Subject: Data Response, Set 1D
Hidden Hills Solar Electric Generating System (11-AFC-2)

Data Response 1D

Hidden Hills

**Data Response, Set 1D
(Response to Data Requests 97 though 135)**

Appendix DR98-1
HHSEGS Project Area
Hidden Hills Solar Electric Generating System

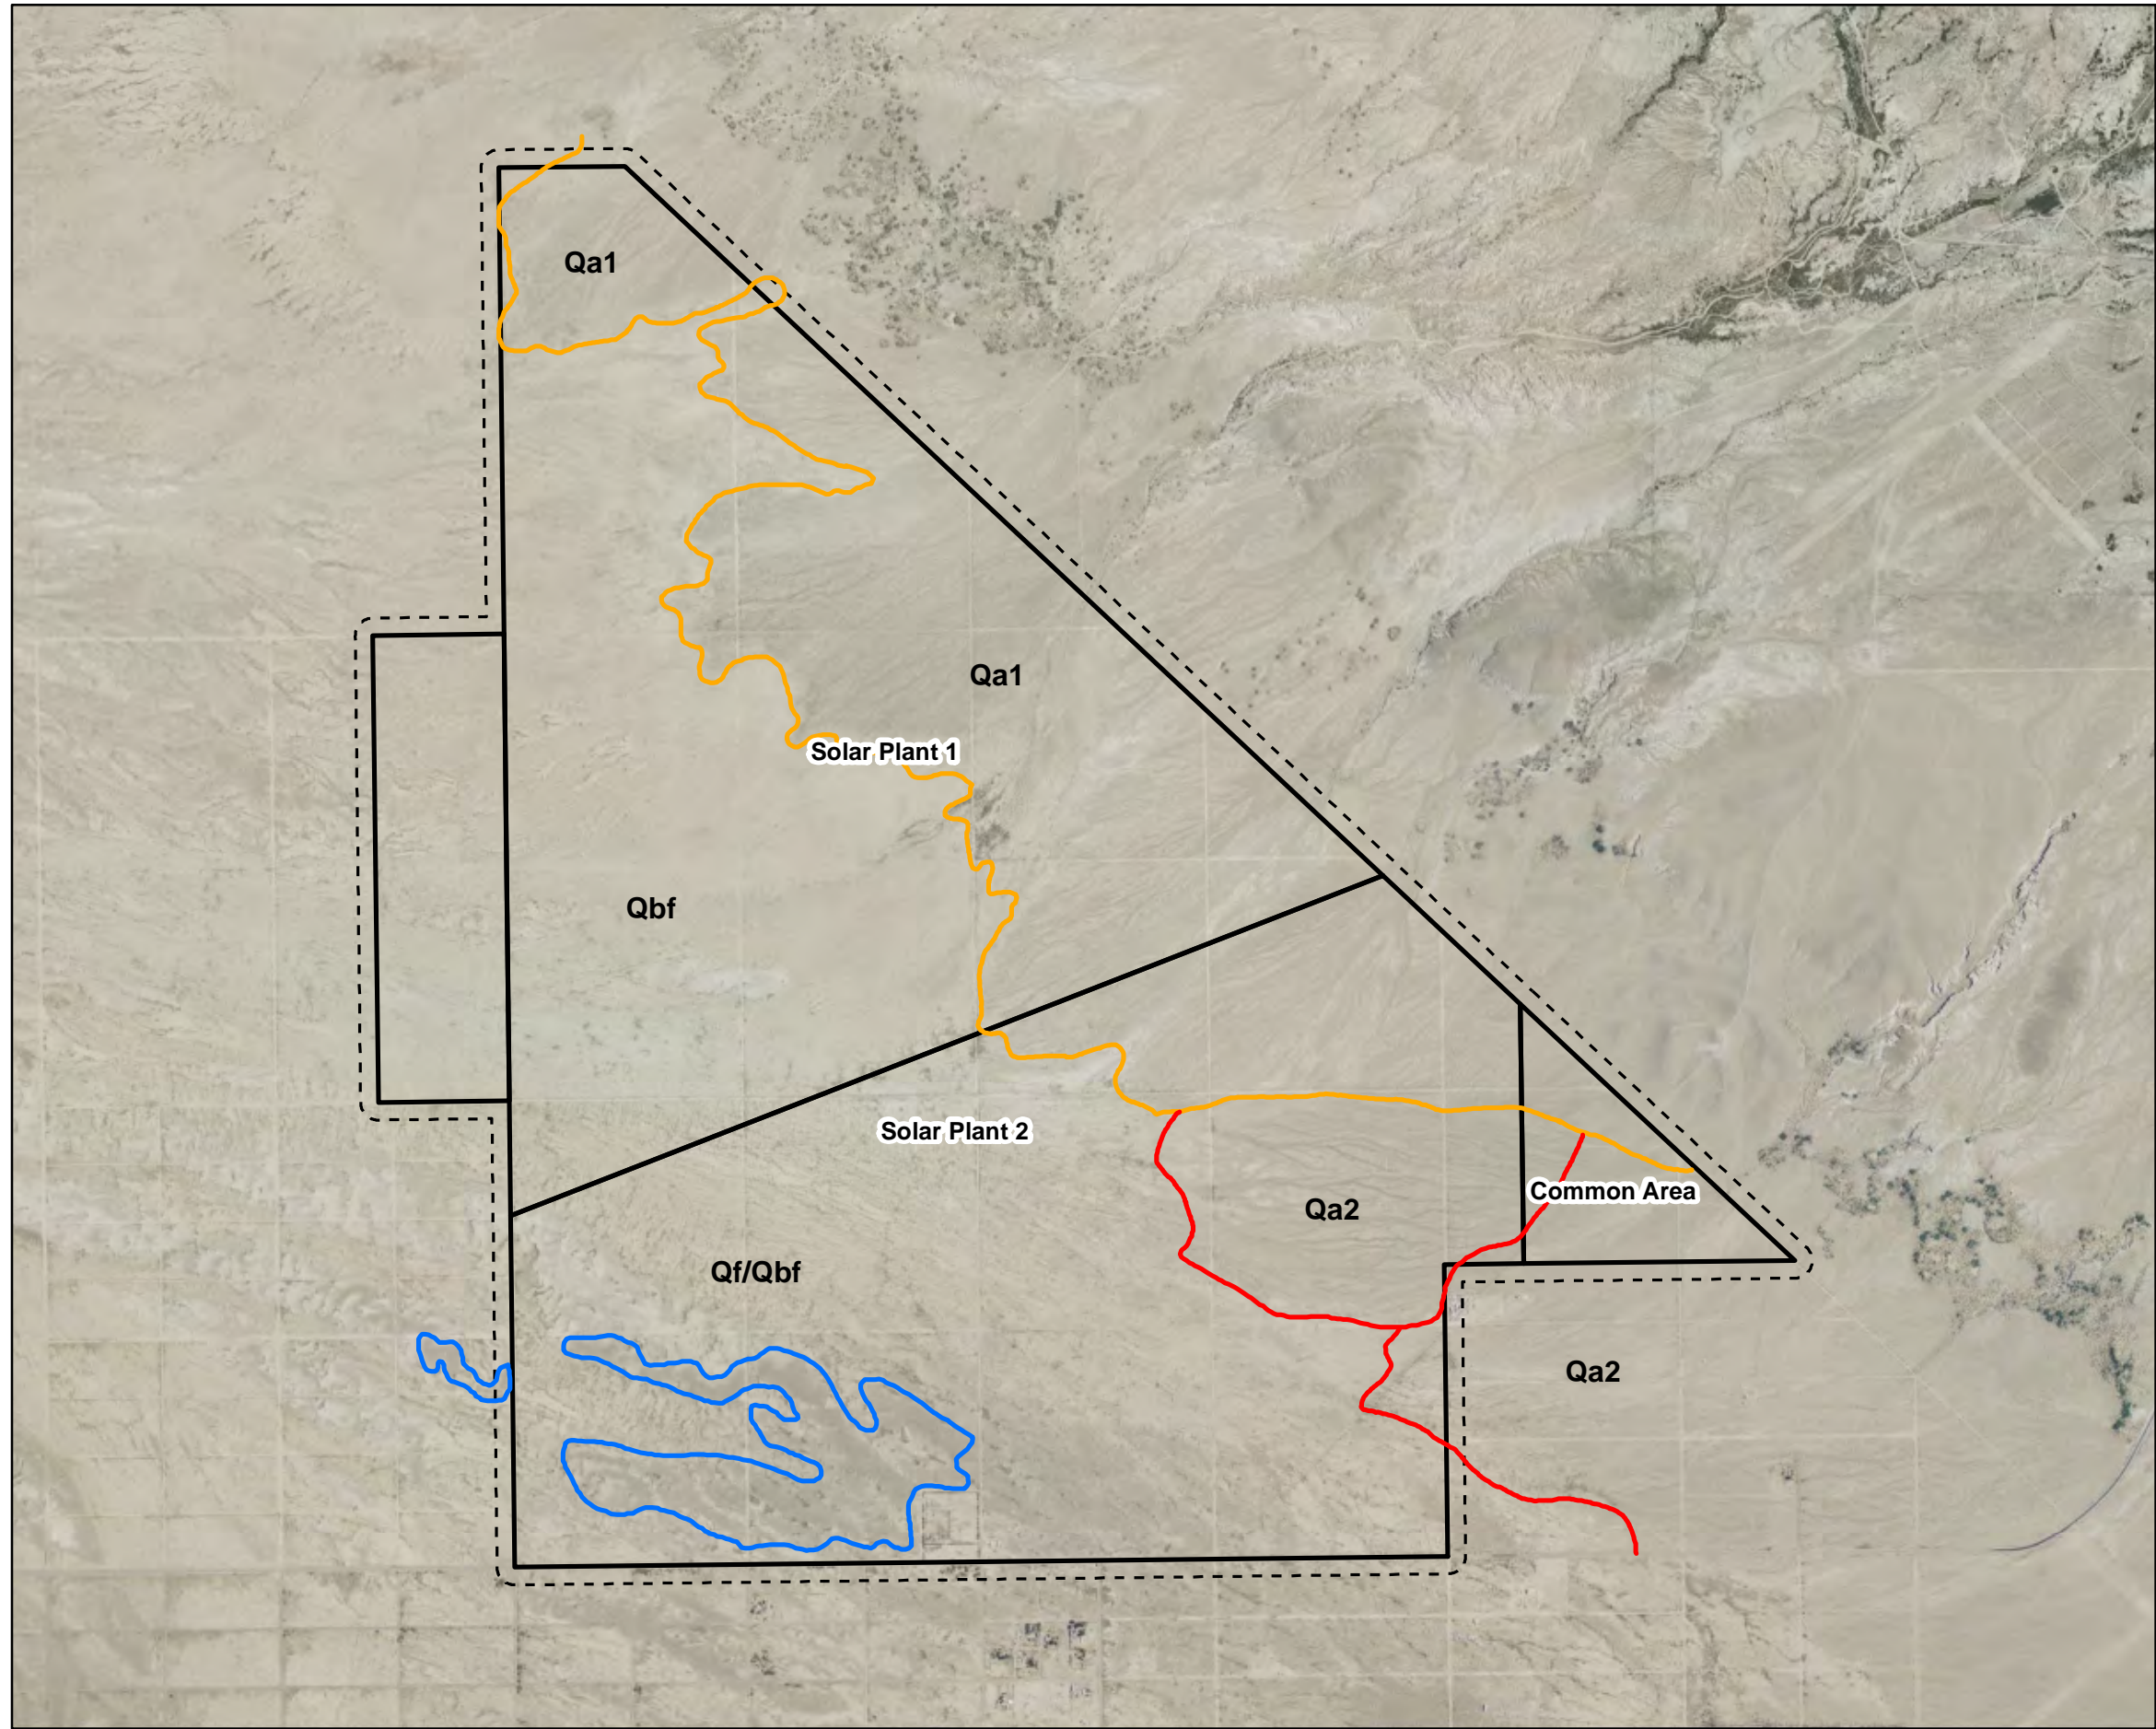
The “project area of analysis” is a concept that staff uses to bound the geographic area in which the proposed project has the potential to affect cultural resources. The effects that a project may have on cultural resources may be immediate, further removed in time, or cumulative. They may be physical, visual, auditory, or olfactory in character. The geographic area that would encompass a consideration of all such effects may or may not be one uninterrupted expanse. It may include the project area, which would be the site of the proposed plant (project site), the routes of requisite transmission lines and water and natural gas pipelines, and other offsite ancillary facilities, in addition to one or several discontinuous areas where the project could be argued to potentially affect cultural resources.

Response: Figure DR98-1 is a map showing the project area of analysis (PAA) appropriate for the resource assessment and impact analysis for the project. It encompasses the HHSEGS project site, the temporary construction laydown area to the west, and a 200-foot buffer around the site. The scope of the PAA is appropriate given that these are the areas potentially affected by the project's activities.

FIGURE DR110-1
Groundwater Dependent Vegetation
in the Southern Pahrump Valley
Hidden Hills SEGS

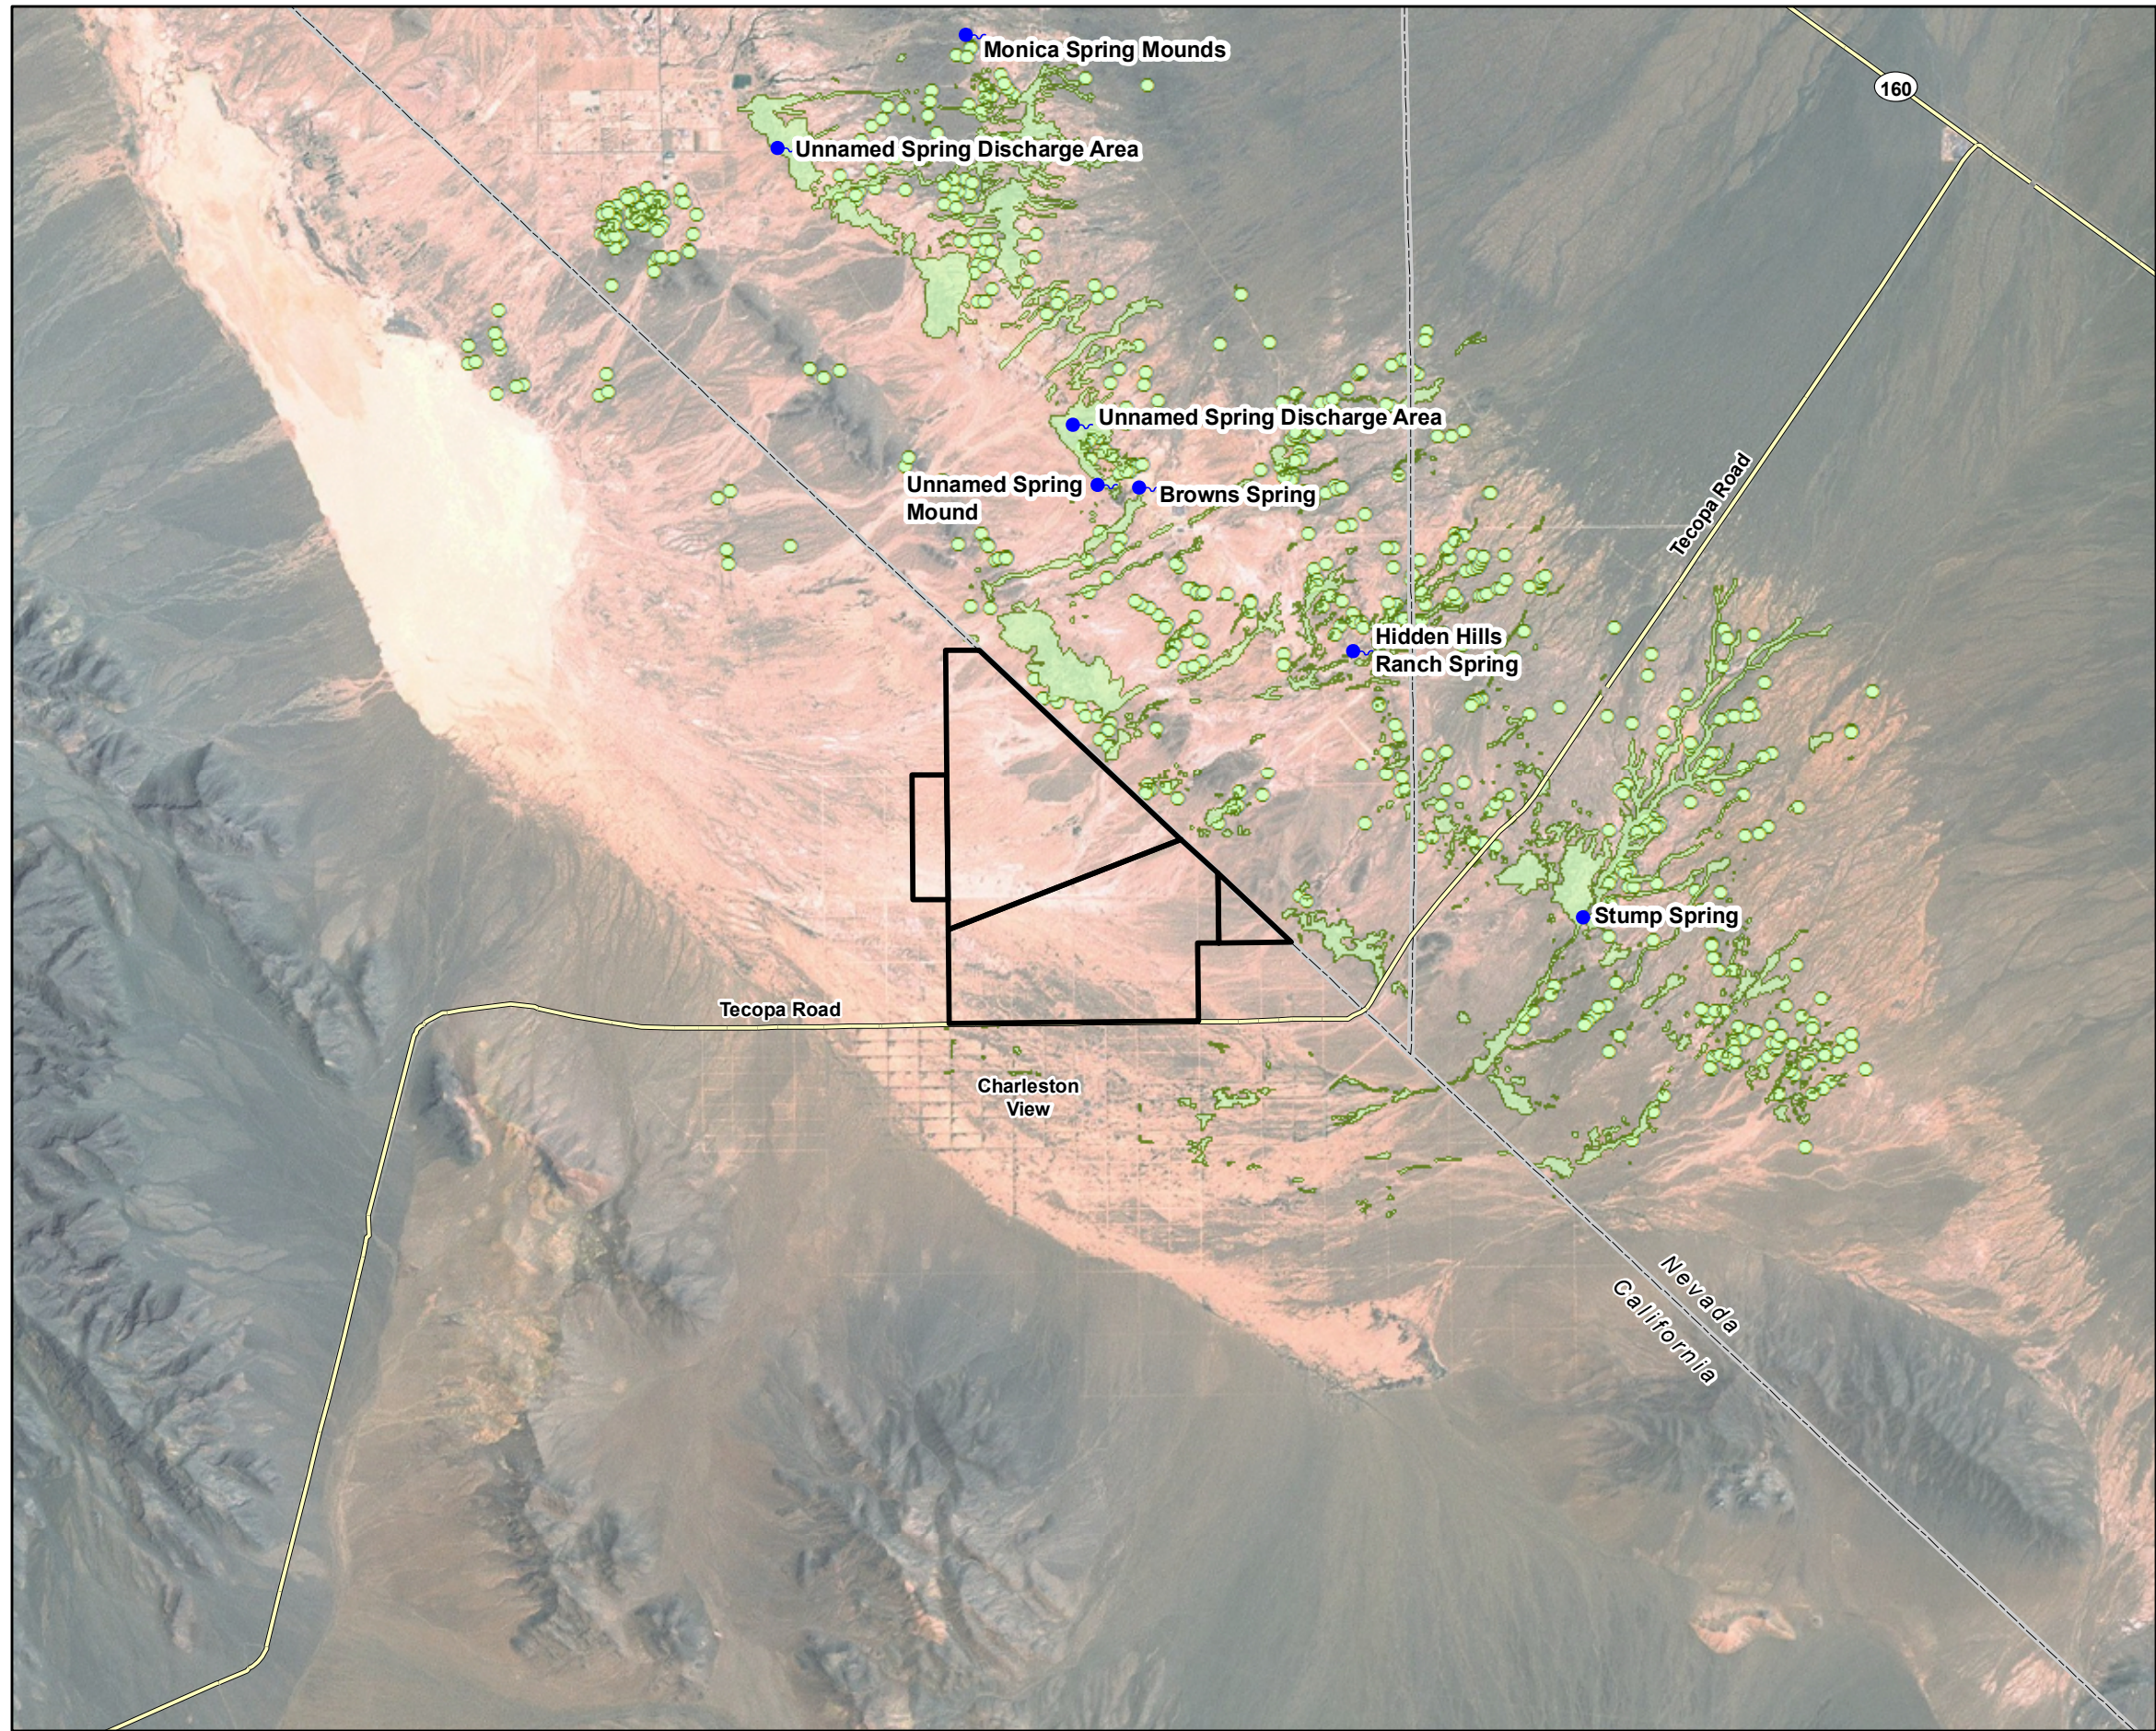
110. Please provide a map at a scale of at least 1:24,000 and sufficient to show the project area and the adjacent vicinity from, at a minimum, Mound Spring to Stump Spring. Depict and label places and historic features including, but not limited to, Hidden Hills Ranch, Manse Ranch, Manse Spring, Mound Spring and associated adobe, Bolling Mound and Bowman habitation sites, Stump Spring, Brown Spring, Old Spanish National Historic Trail, documented Old Spanish Trail/Mormon Road segments in Figure 3 of technical report, and any other places or historic features that are important in the history of the project area vicinity.

Please see Confidential Figures DR107-1a through e for the locations of the Bolling Mound and Bowman habitation sites. The historic Hidden Ranch, now known as the Hidden Hills Ranch, is labeled on the USGS topographic base map on Figure DR107-1a through e. The Manse Ranch, purchased by the Bowmans in the 1940s, is situated in the same location as the Bowman Site, NY-809. The Old Spanish National Historic Trail is shown on Figure 3 of the technical report. The above springs are shown on Figure DR110-1.

Information on the named springs, and other known discharge areas, within about 6 miles of the PAA had been gathered for a prior data request (Data Response 48) relating to biological resources. These data are provided again, this time with the springs labeled, in Figure DR110-1. Also shown is the extent of groundwater-dependent vegetation, primarily mesquite thicket, associated with areas of shallow groundwater. The maximum, Pleistocene extent of those groundwater discharge systems is represented by the white to buff sediments with high reflectivity (Figure DR110-1).
